Southwestern Pennsylvania Road Safety Audit

**S.R. 837 (Carson Street) from Station Square to
the West End**

City of Pittsburgh, Allegheny County, PA

September 2013

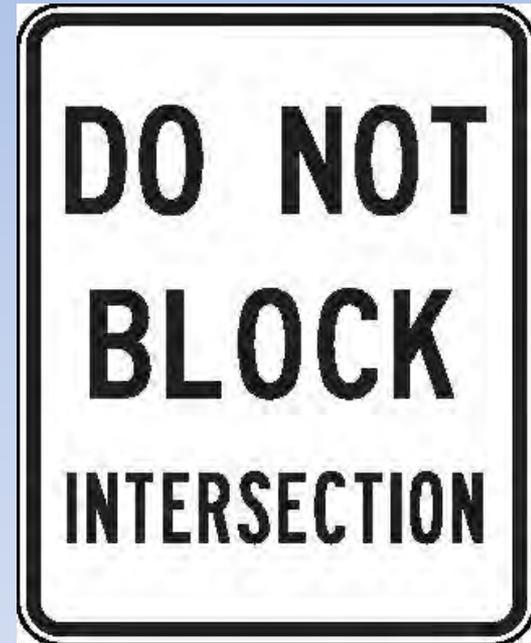
OBSERVATION: Traffic blocks the gas station driveway and partially closed ramp. When the officer tries to change the signal, it must go through a full phase at the gas station whether it is needed or not.

- Install 'Do Not Block Intersection' signs.
- Give traffic officer more control over the signal so that he/she can choose which signal phase to call (i.e. which approach to turn green (if possible)).

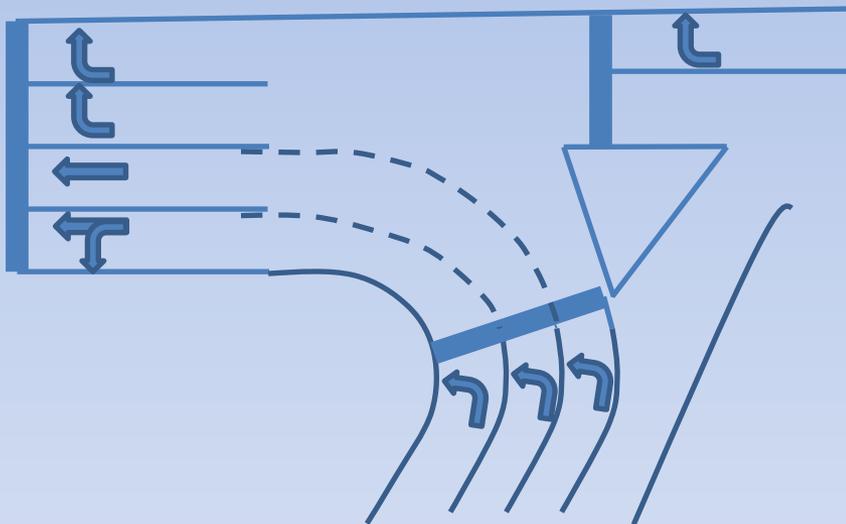
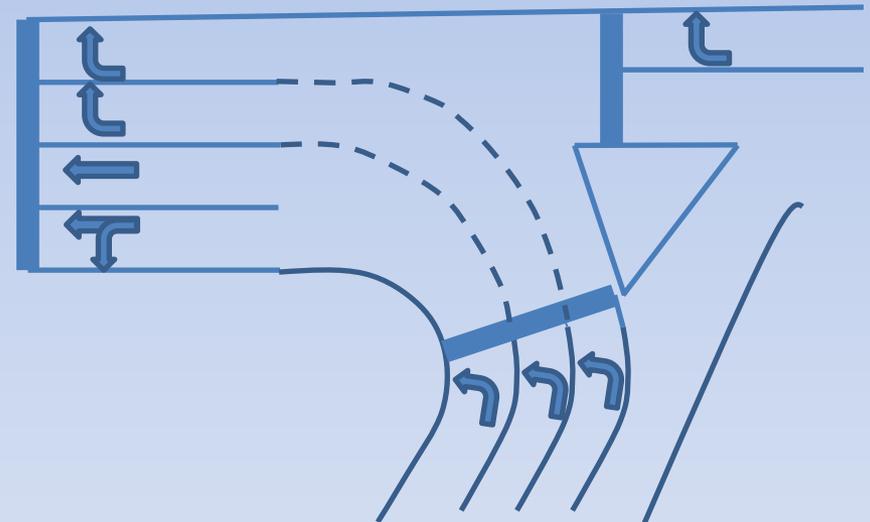
OBSERVATION: Tracer lines do not match the current signal plans. Most vehicles in the middle left turn lane are destined for the West End Bridge, but the current tracer lines do not direct them into those lanes.

- Modify triple left tracer lines so that:
 - Left lane leads to left turn lane and left/thru turn lane.
 - Middle lane leads to the inside right turn lane.
 - Right lane leads to outside right turn lanes.

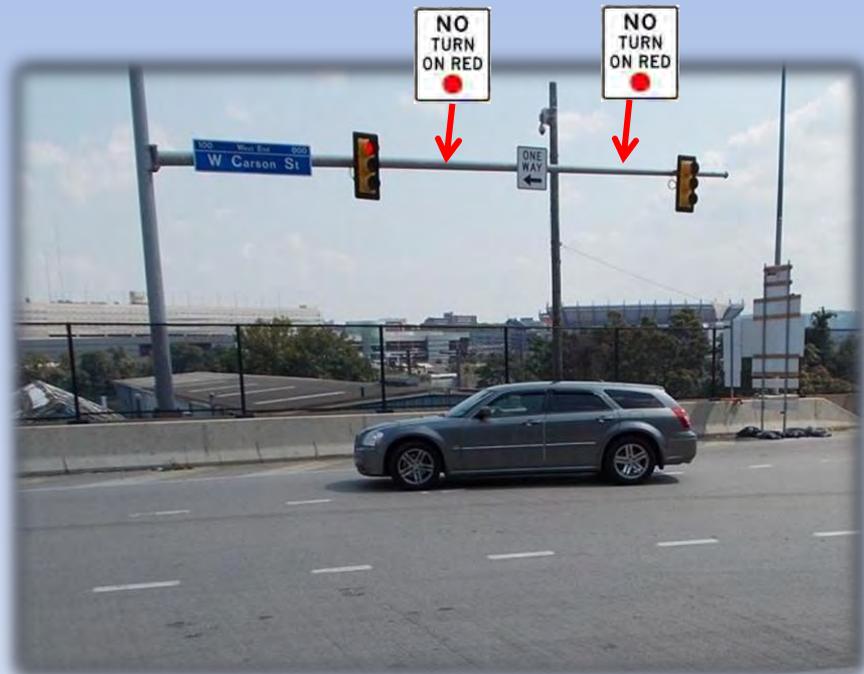
OBSERVATION: Numerous motorists were observed making left turns onto Carson Street from South Main Street during the red phase (from all 3 turn lanes). A pedestrian crossing phase is programmed to “WALK” across these left turns on red. This creates vehicle-ped conflicts.

- Install NO TURN ON RED signs and/or red arrow signal heads on South Main Street approach.
- Consider installing Automated Red Light Enforcement devices.
